RE: Certificate of Authorisation for Carcur Closed landfill Application Register No. H0002-01. Response to Request for Further Information issued by the EPA Office of Climate, Licensing and Resource Use dated 8 September 2011

CARCUR CLOSED LANDFILL SITE – APPLICATION TO EPA FOR CERTIFICATE OF AUTHORISATION

RESPONSE TO REQUEST FOR FURTHER INFORMATION INTERIM SUBMISSION

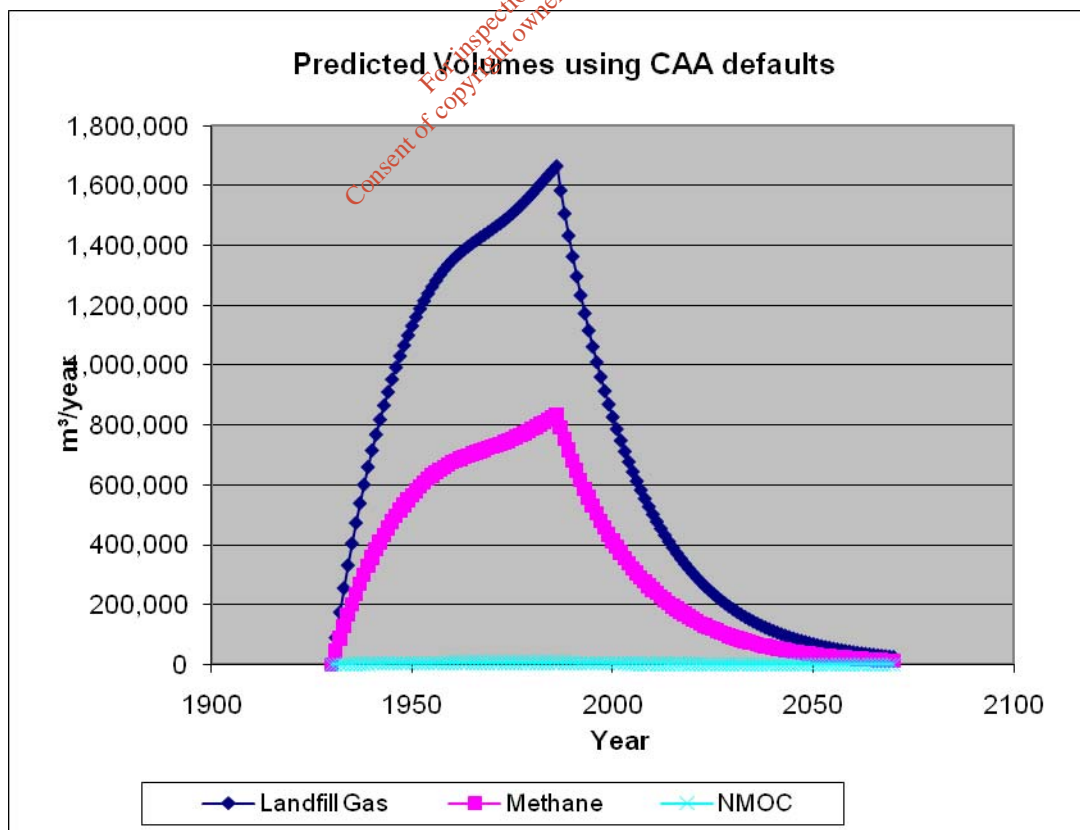
- i. On the Waste Management Act Section 22 Register, it has been stated that the area of the waste is approximately 5.5 ha. If the waste body is >5 ha the leachate and landfill gas source hazard scoring matrix scores should be increased from 7 to 10 as outlined in the Code of Practice (COP). Clarify the area of waste and if necessary recalculate the relevant SPR linkage scores.

Insofar as can be determined from trial holes and site investigations, the area of the waste body covers up to 6.3 ha.

Referring to Table 1a and 1b of the COP, pre 1977 sites, i.e. those that were 30 years old at the time of publication of the COP are given a rating of 3 (if greater than 5 ha). A large part of the site was used as a municipal landfill from 1933 to 1985. The majority of the landfill area was in-filled during the 1960s and 1970s. The site closed in 1985 and has not been used since for any purpose. Thus the majority of the site is more than 30 years old and a small part is less than 30 years old.

The effect of age is natural biodegradation of the waste. Referring again to Table 1a, it could be argued that, from a biodegradability perspective, the site is now more akin to a C&D waste landfill than to a municipal waste landfill.

Using the landfill gas prediction model (below) for the site it is clear that the predicted biodegradability of the waste is, by now, less than one third of that when the landfill was operational.

It can be argued that the site is 70% metamorphised from biodegradable to inert thus a lower score could well be applied both to 1a and 1b.
